APPLICATION NO.	FILING DATE	FIRST NAMED INVENTOR	ATTORNEY DOCKET NO.	CONFIRMATION NO.
09/966,427	09/28/2001	Harini V. Sundaresan	TI-31767	6354
23494	7590	03/09/2005	EXAMINER	
TEXAS INSTRUMENTS INCORPORATED			TORRES, JUAN A	
P O BOX 655474, M/S 3999			ART UNIT	
DALLAS, TX 75265			PAPER NUMBER	
			2631

Office Action Summary

DETAILED ACTION

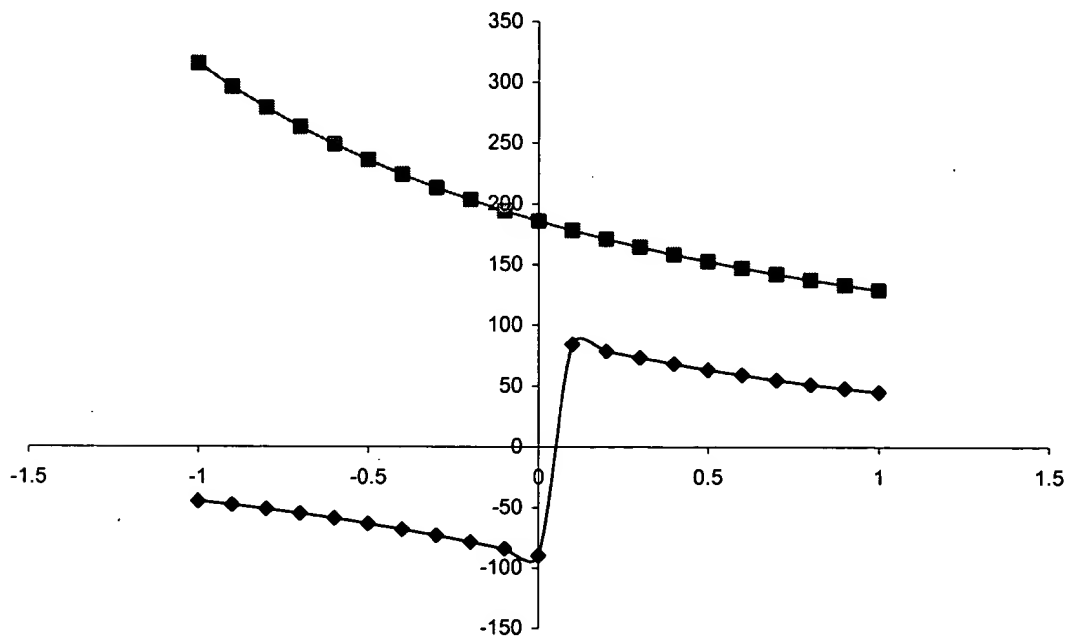
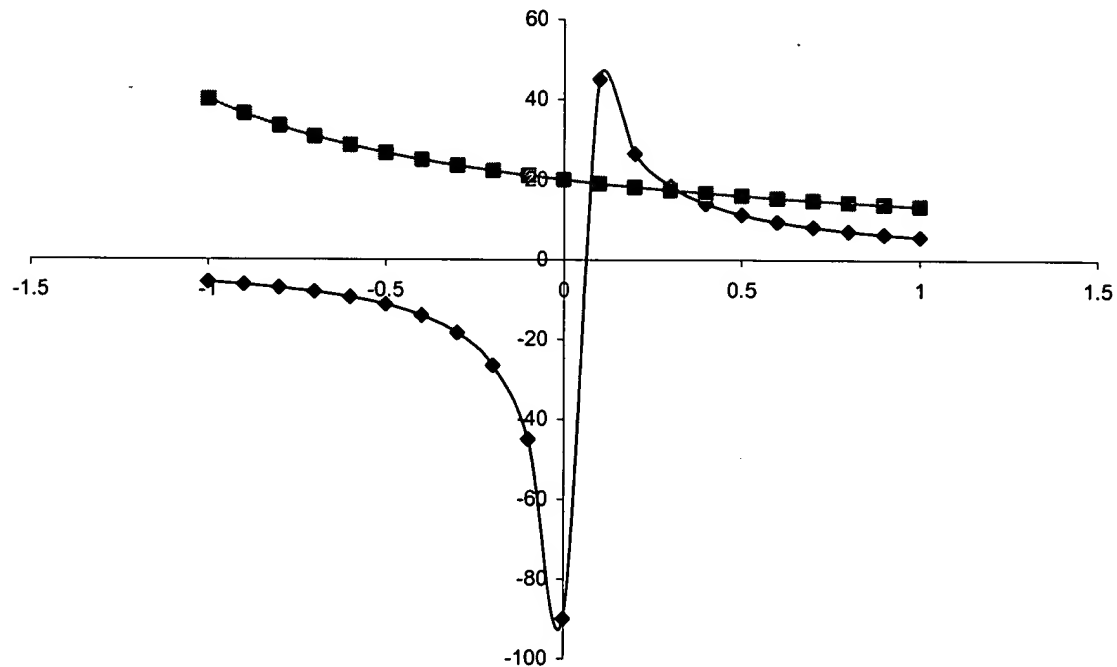
Claims 1-10 rejected under 35 U.S.C. 101 because the disclosed invention is inoperative and therefore lacks utility. The disclosure present a method for computing the value of arctangent (IM/RL) and $7 \times \arctangent (IM/(RL+2))$ in all the values of IM in $[-1, 1]$, and RL in $[-1, 1]$. The following graphic is a representation of the two values of arctangent (IM/RL) and $7 \times \arctangent (IM/(RL+2))$ (in the OY axes) for the case where $IM=1$ and RL from -1 to 1 (in OX axes):

It can be seen that this approach proposed is not valid in any range of values. The same representation for a value of $IM=0.1$ is:

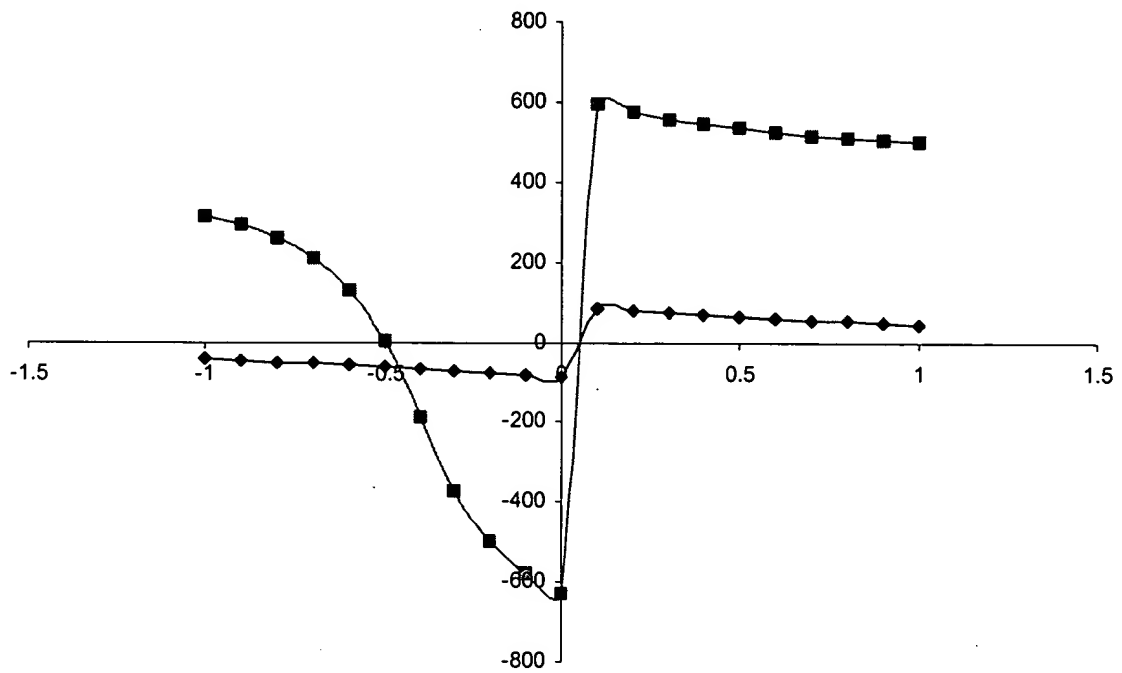
It is evident that the approach is not good at all. The proposed claims lack of utility in the full range of the disclosure.

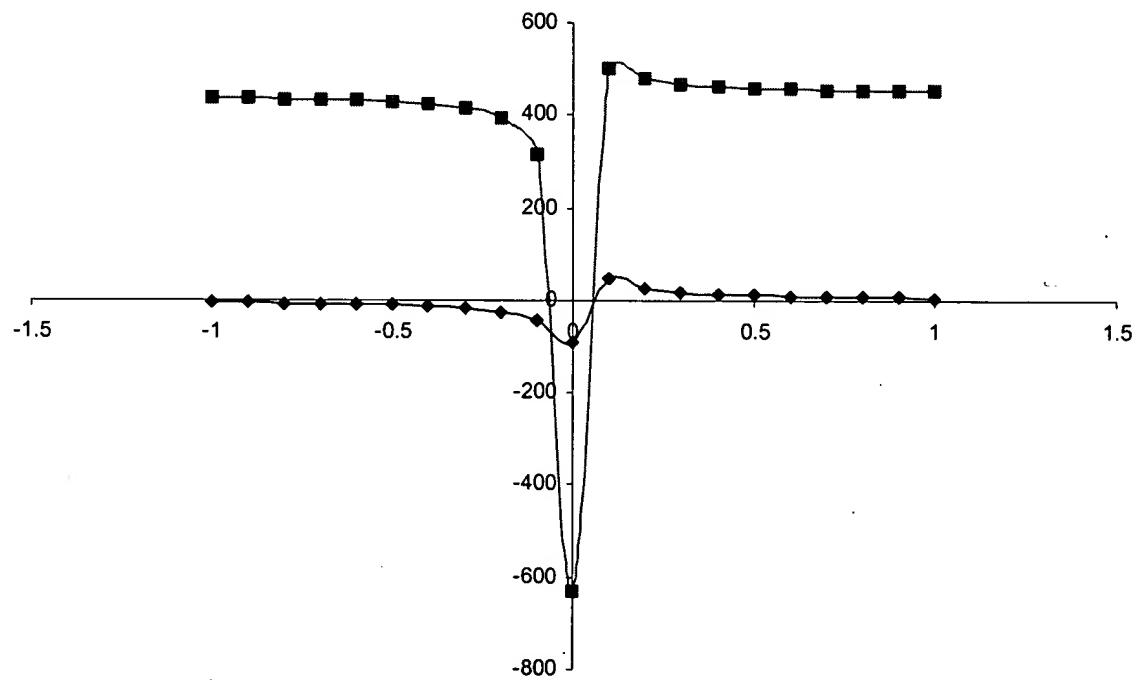
In the case that the application means the value of $((IM/RL) + 2)$ instead of $(IM/(RL+2))$ the approach will also not be true (this case will not be supported by the disclosure). In the case $((IM/RL) + 2)$ for low values of RL the number 2 is depreciable compare with (IM/RL) and in those cases $(RL \ll 1)$ the approach will be possible, but with no gain in burden complexity because still the value (IM/RL) have to be computed for RL close to zero. This situation can be shown in the following graphic for the case $IM=1$.

In the case of $IM=0.1$ the representation will be:
